DANE COUNTY DEPARTMENT of PUBLIC WORKS, HIGHWAY and TRANSPORTATION

RFB NO. 313086 - ADDENDUM NO. 5

ARCTIC ANIMAL EXHIBIT AND CONCESSIONS

This Addendum is issued to modify, explain or clarify the original Request for Bid (RFB) and is hereby made a part of the RFB. Please attach this Addendum to the RFB. **Bidders must acknowledge all Addenda on the Bid Form.**

SR1.2

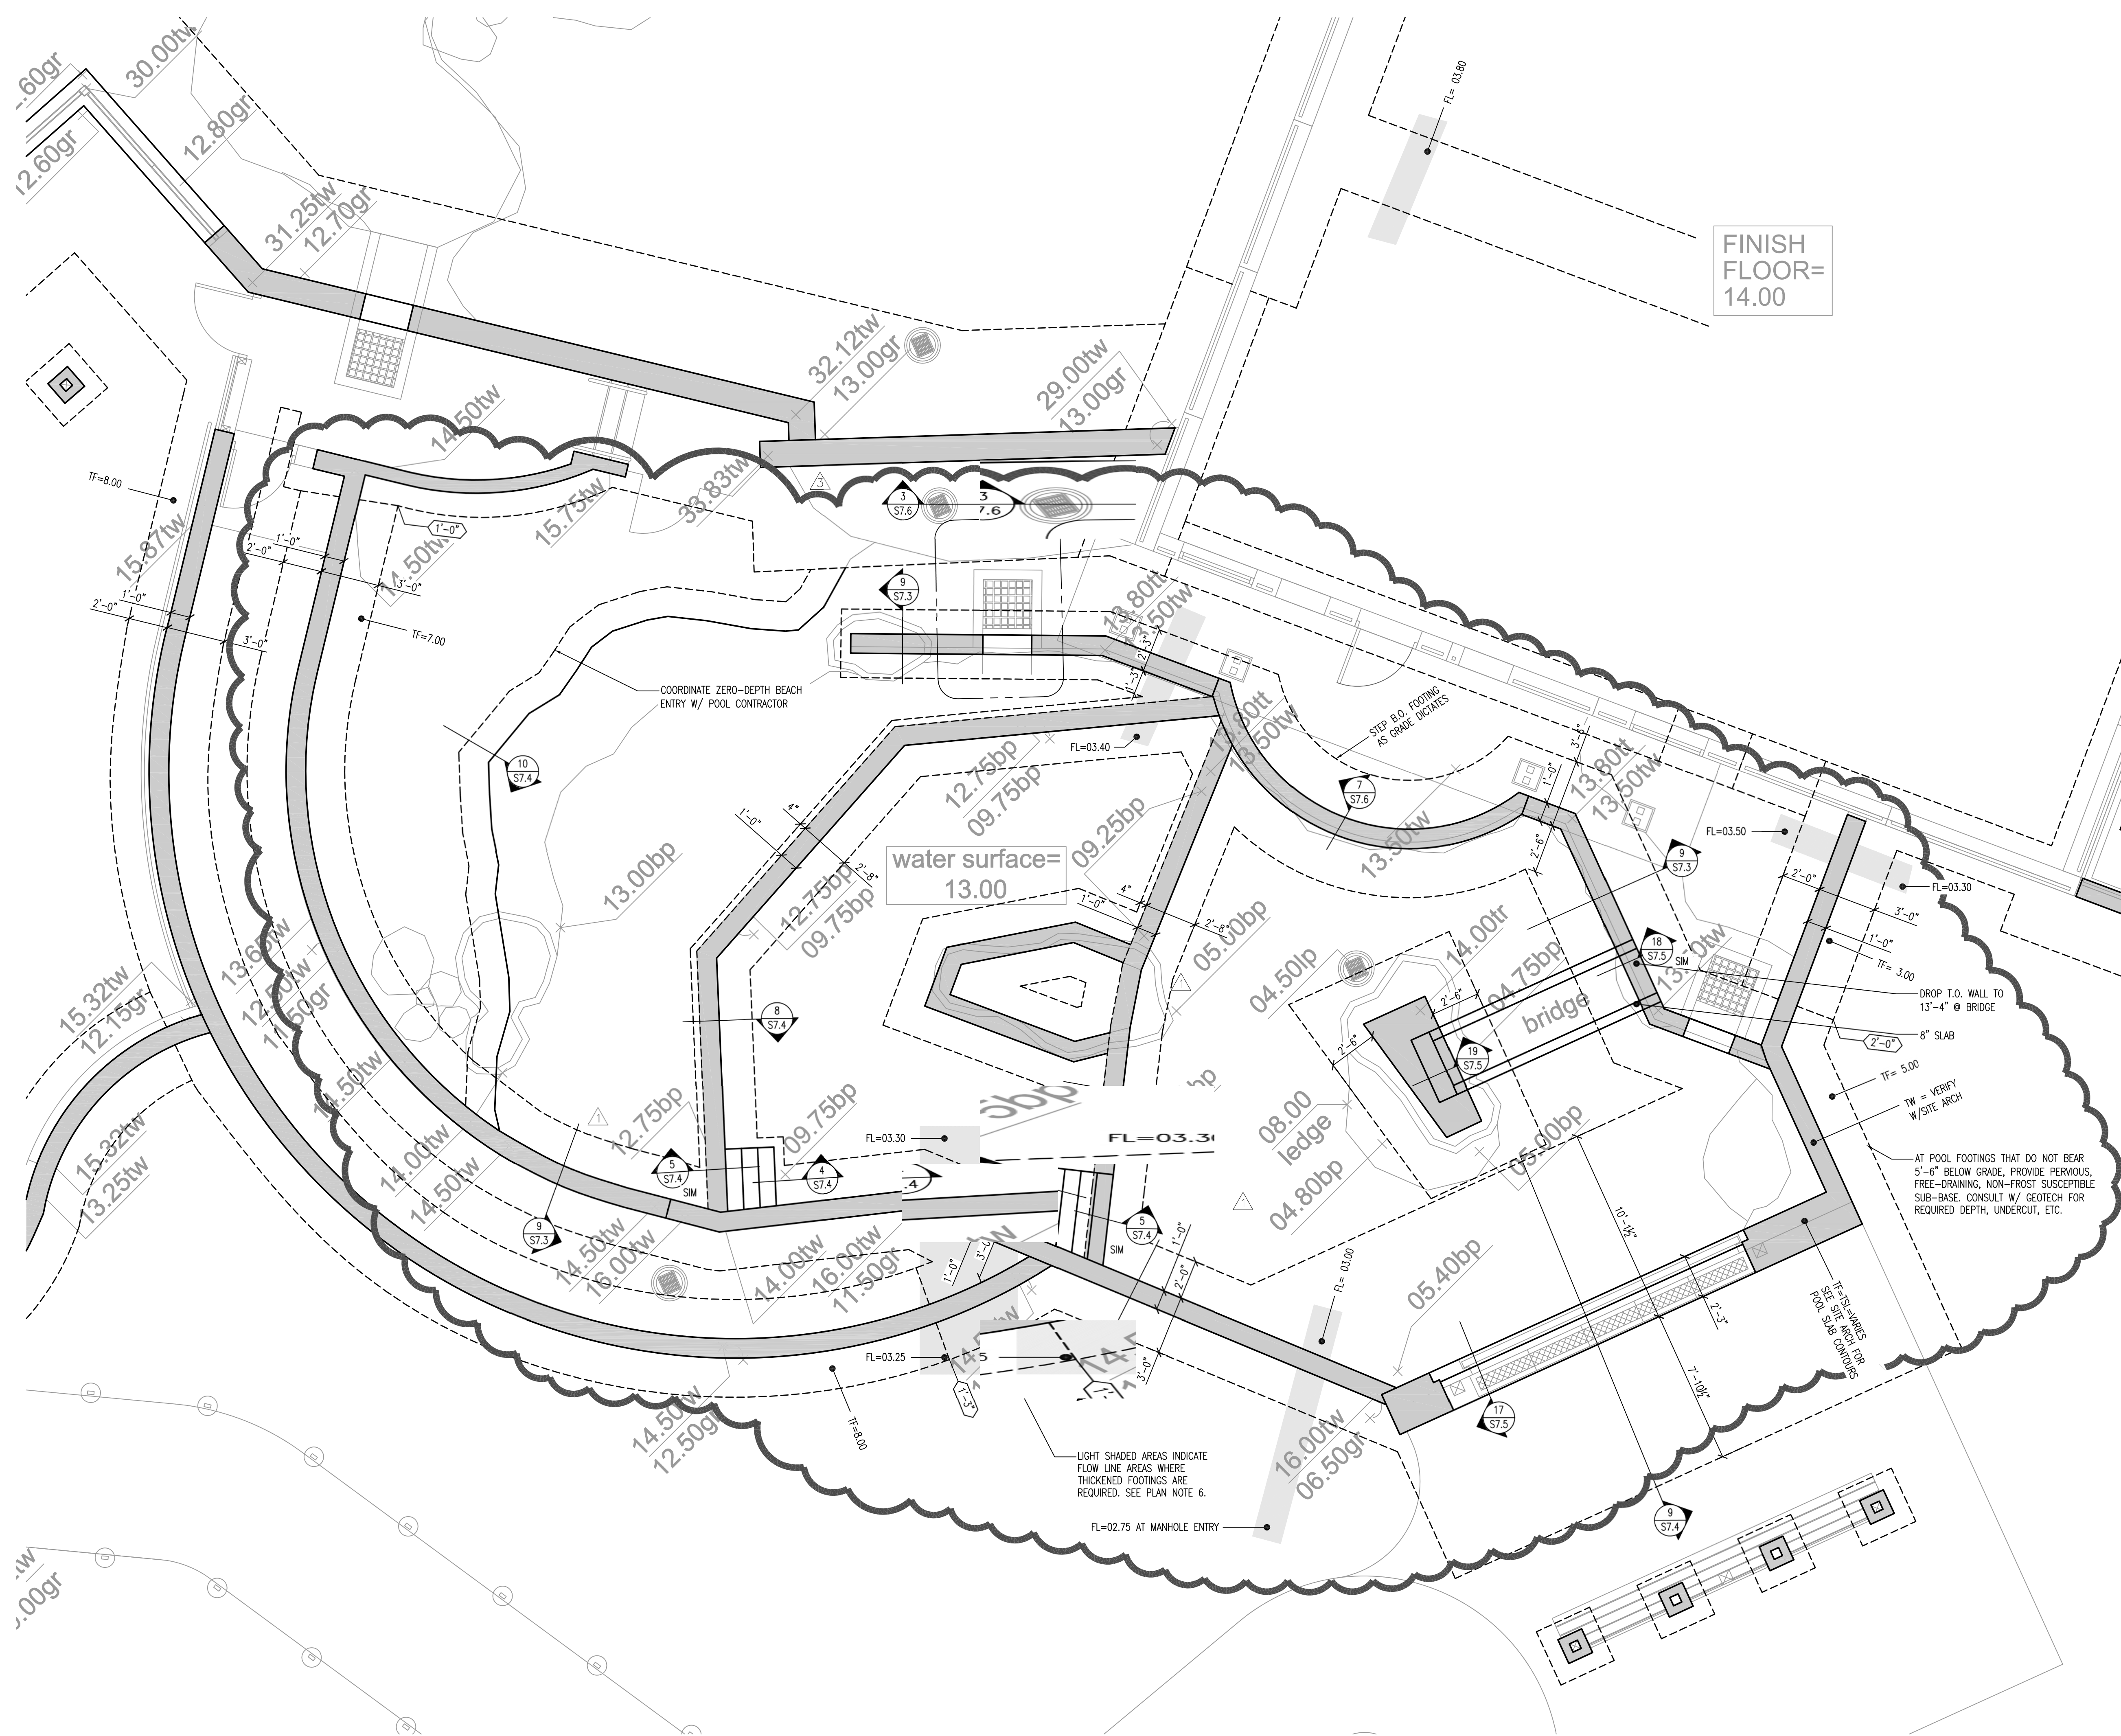
- Added 'At footings that do not bear 5'-6", use...non-frost susceptible sub-base' note
- 47. SR1.2 – Retaining Wall Partial Site Plan**
 - Revised T.O Footing and added footing steps in multiple locations to meet Geotech Report requirements.
